R E M A R K S

SHOWA CORP.
10/636080
Page 2 of 8

FIG.6A

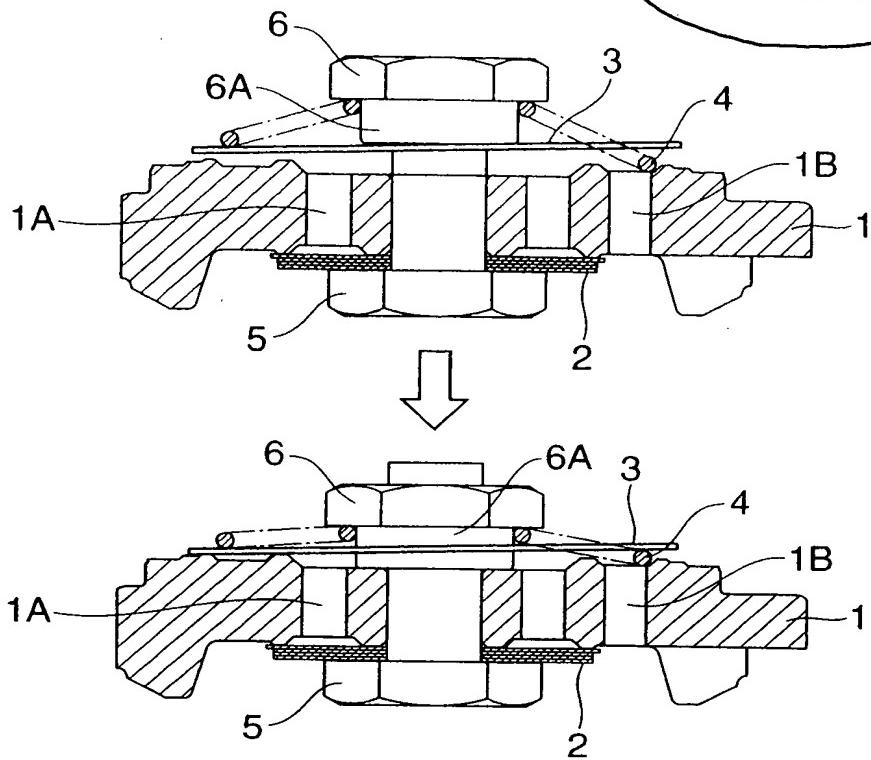
Applicant proposes amending Figures 6a and 6b to include the legend "Prior Art." The proposed amendment is highlighted in red.

Proposed Drawing Amendments to Figures 6A and 6B are shown circled in Red.
Proposed New Figure 7 is attached. No new matter has been added.

PRIOR ART
